Product / Process Change Notification

N° 2020-112-A

Change of Assembly Production and Final test from Tianshui Huatian Electronic Group CO., Ltd (TSHT), China to Huayi Microelectronics Co., Ltd (HYME), China for CoolMOS™ products in TO251/TO252/TO220Fullpak packages

Marking pattern

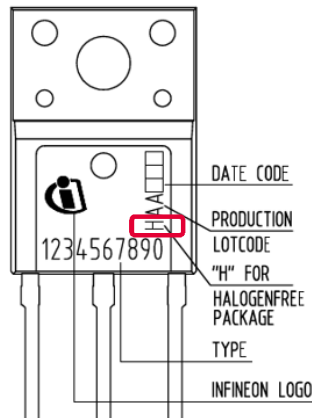
- ❑ For TO251 and TO252 variants the production lot code remains the same at HYME, starting with “H”.

- ❑ For TO220Fullpak variants the production lot code will be standardized at HYME, starting with “H”.
